Access Report

Newcastle Golf Club  
Retirement Living  
4 Vardon Road  
FERN BAY NSW 2295

For: Principle Living  
Ref: PAA\_23473

Lee-May Whong	Draft	Issued for review	23 November 2023
Lee-May Whong	Revision 1	Issued for DA	12 December 2023
Lindsay Perry	Revision 2	Updated for Council RFI	1 July 2024

Figure 6 | Buildings 1, 2 & 3

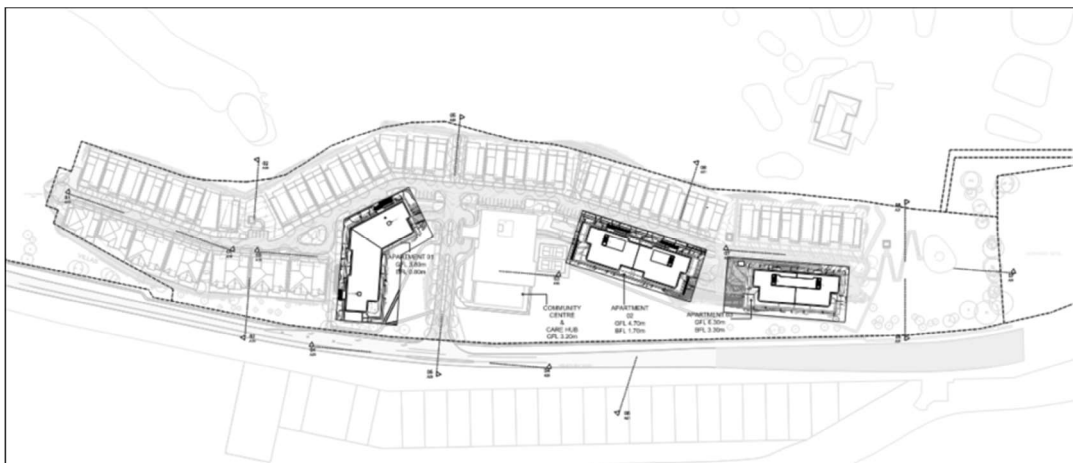
Double hinged doorways provide entry to the building and offer compliant circulation areas. Ensure that the selected door enables a clear width of 850mm for single leaf operation. A level threshold hold is achievable at the doorway.
